## MEETING AGENDA

### Appearance Commission

Village of Homewood

September 01, 2022

1 PHOTOMETRIC PLAN  
1/16" = 1'-0"

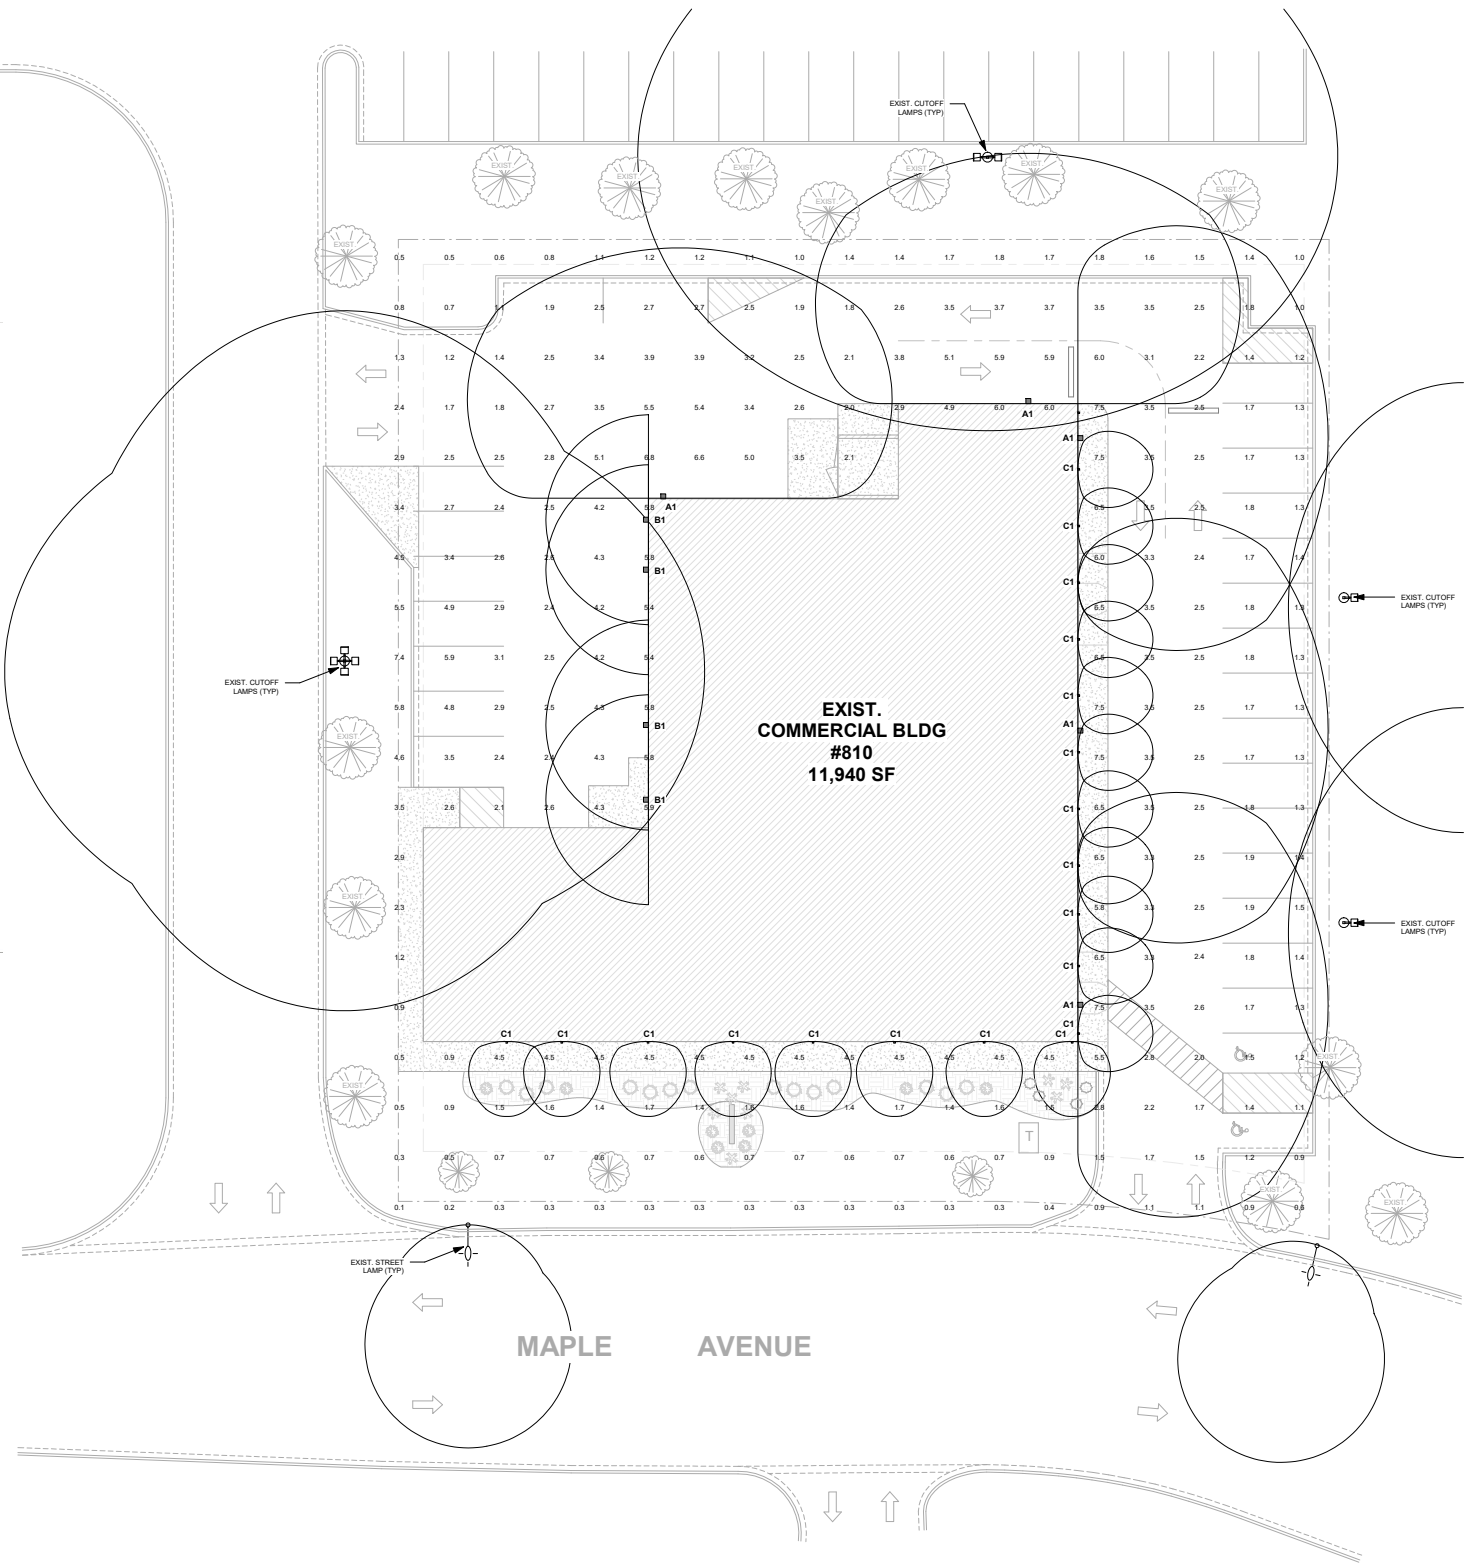
New wall-mounted lights are proposed for the building: architectural sconces between each of the storefront windows on the primary facades and utilitarian wall pack lights on the two secondary facades. Both will be LED's. Additionally, wall-mounted flood lights are proposed for illuminating the parking lot to the north and east of the building.

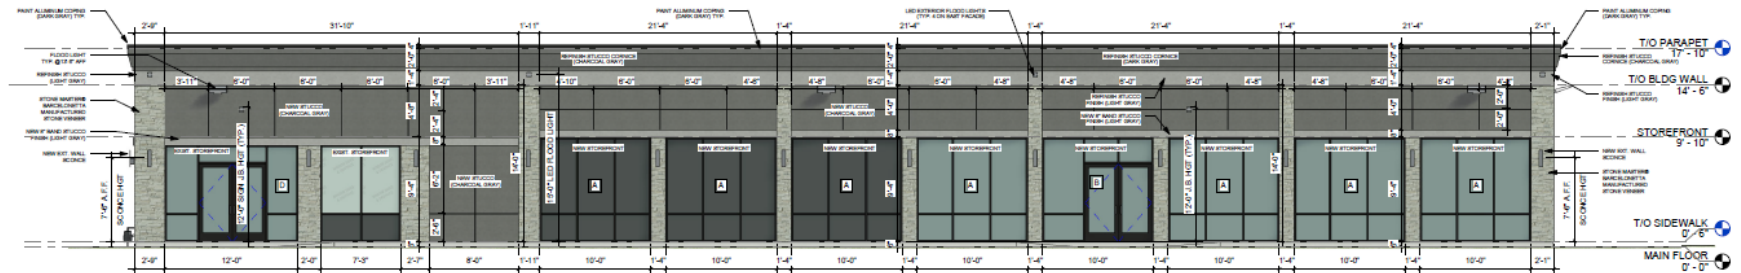
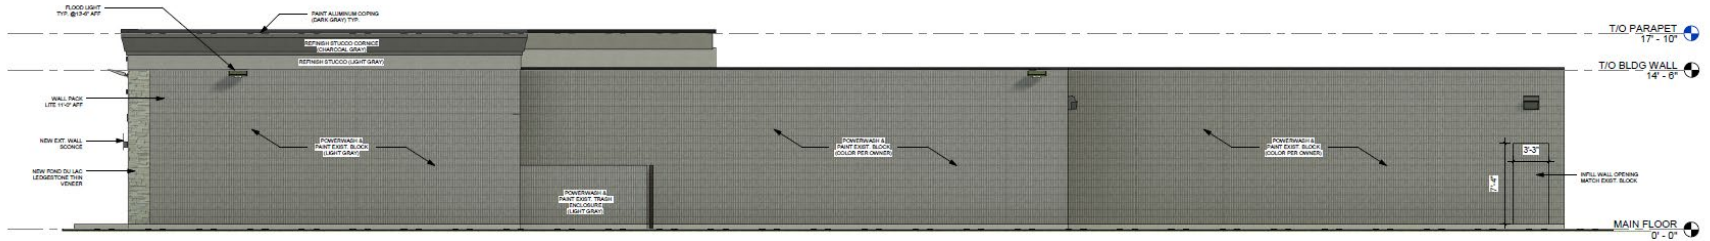
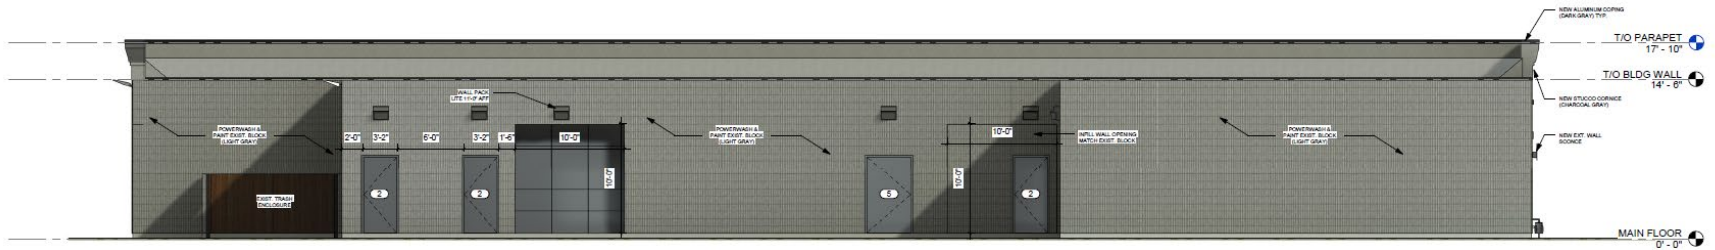
The existing building is primarily composed of a beige ribbed concrete block with a glass storefront and overhead doors on the two primary facades. The proposed improvements will re-clad the two primary facades- the south facing Maple Avenue and the east facing the internal parking lot and drive aisle- with a manufactured stone veneer (Stone Master's "Barcelonetta" joint-less stacked stone, color: Sahara) and stucco in charcoal grey and pewter. The new stone veneer will be the primary material from grade to the top of the windows, with some elements extending to the base of the cornice line to create vertical piers. Above the window line, the new stucco will cover the existing ribbed concrete block and introduce new texture and definition through use of the two grey tones.

The south elevation, facing Maple Avenue, has a large amount of storefront glass and two entrances. The proposed improvements will maintain the existing storefront windows.

Turning the corner, the southern part of the east elevation continues the storefront glazing and building entrance similar to the Maple Ave façade. The remainder of the elevation, as it exists, features eight overhead doors that provided access to the tire-change bays. The proposed improvements will replace the overhead doors with new glass storefronts, similar to those existing in the building, and provide a new entrance to a tenant space at the northern end of the building.

The secondary elevations (north and west) will retain their ribbed concrete block and be painted to match the new finishes. Proposed improvements to the west elevation will reconfigure exterior doors, including relocating an overhead door.

The floor plans show that almost all of the storefront windows will be obscured by interior walls. From the exterior, the building will present an attractive appearance, but it will not convey transparency to the public. Staff recommends that the Commission consider requiring a greater level of transparency on the façade (minimum 50% transparency per elevation, from 2.5' above grade to the top of the windows) to promote health and safety for store occupants and vitality for the businesses.

...subject to providing a minimum 50% transparency per primary elevation, within the zone measured from 2.5' above grade to the top of the window.

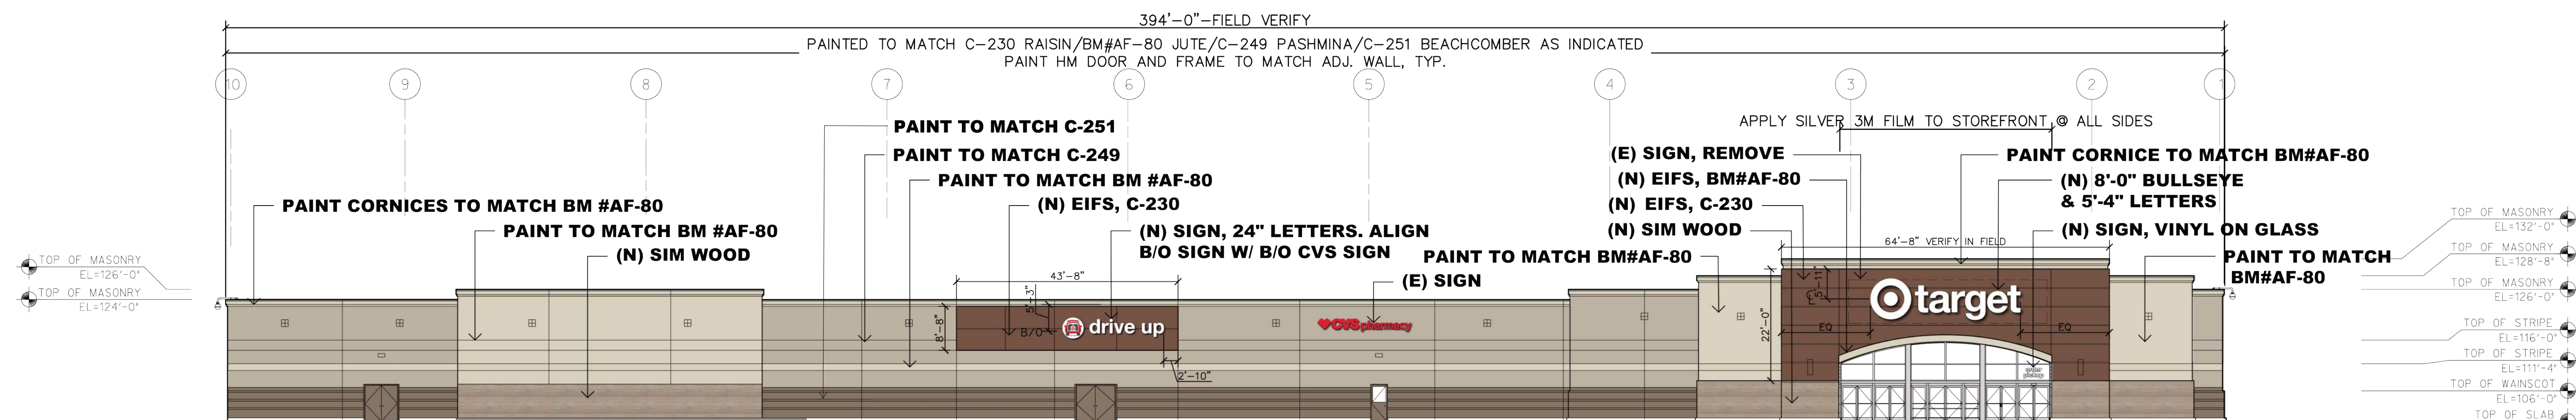
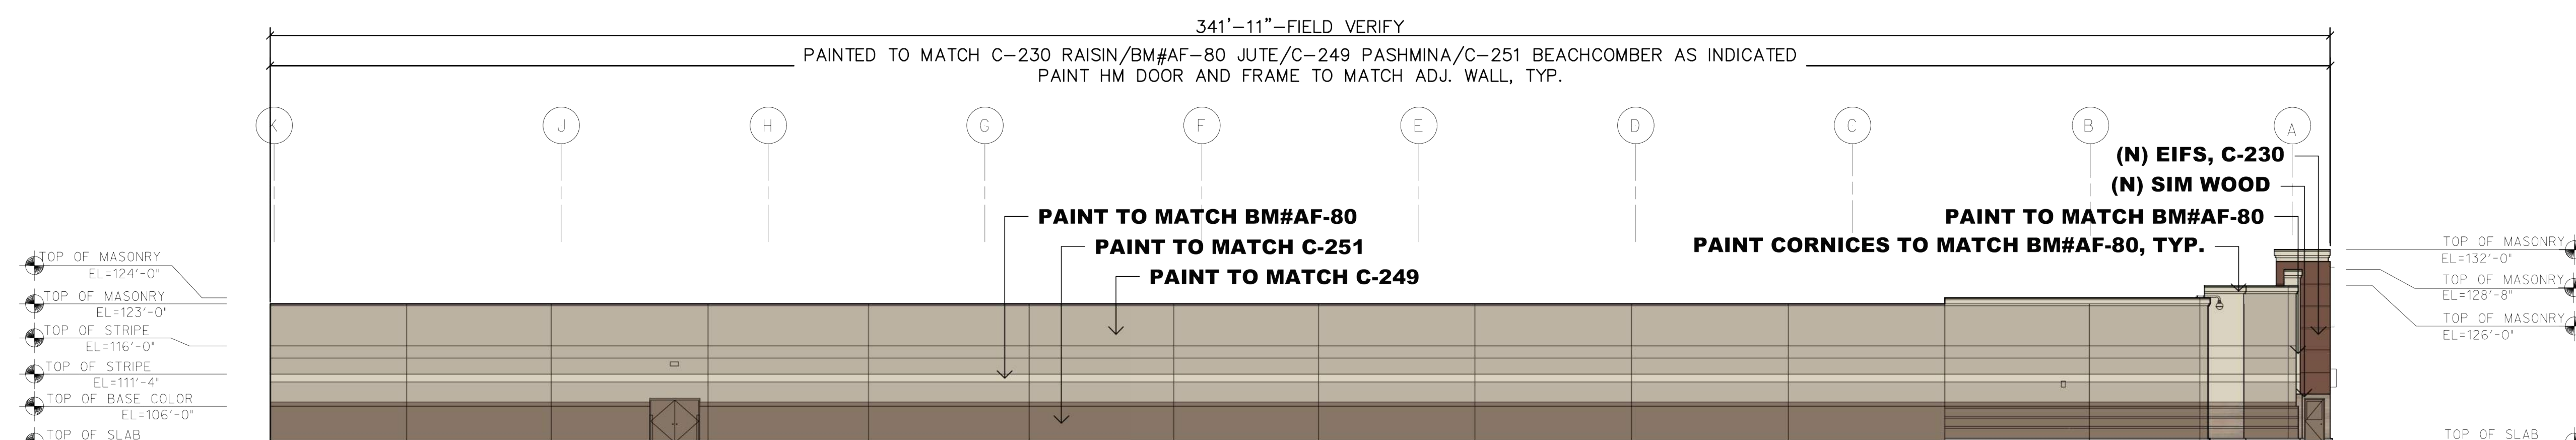
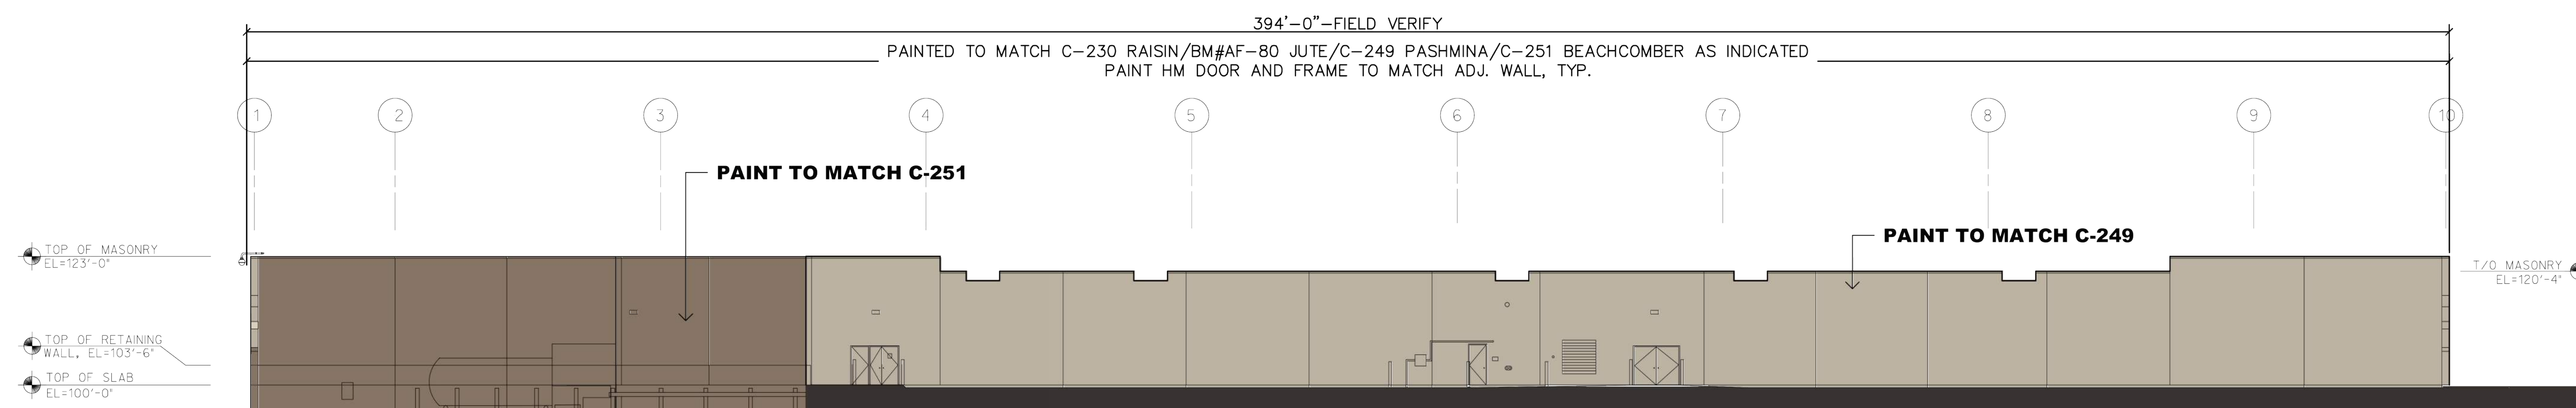
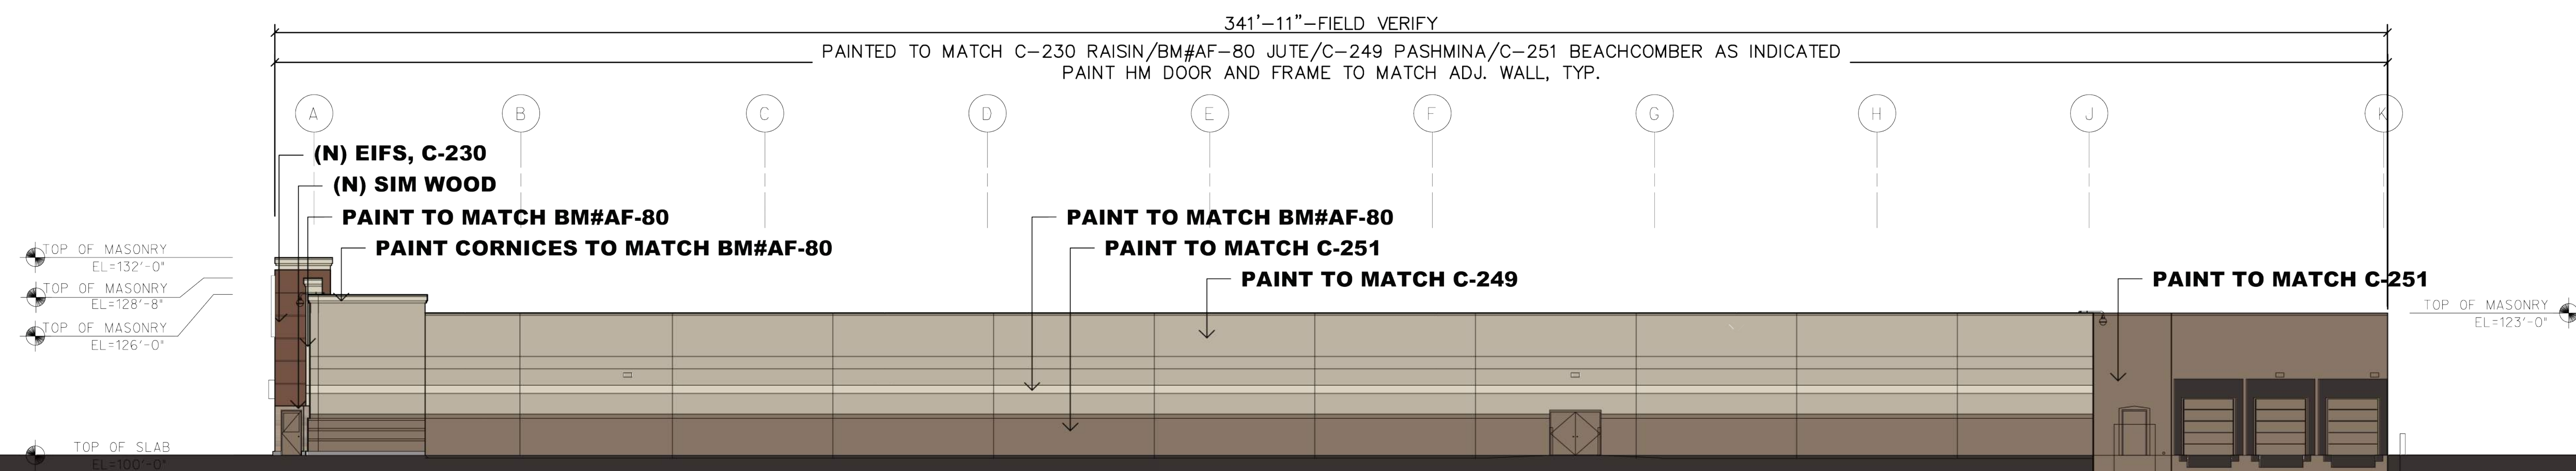
Target proposes new paint colors and accent materials, and signage on the building and the site to support the online order pick-up process. The subject property is a part of the Park Place Plaza Planned Unit Development.

Recommend approval of a variance from the maximum gross sign area for an increase of 150 sf for Target at 17605 Halsted Street.
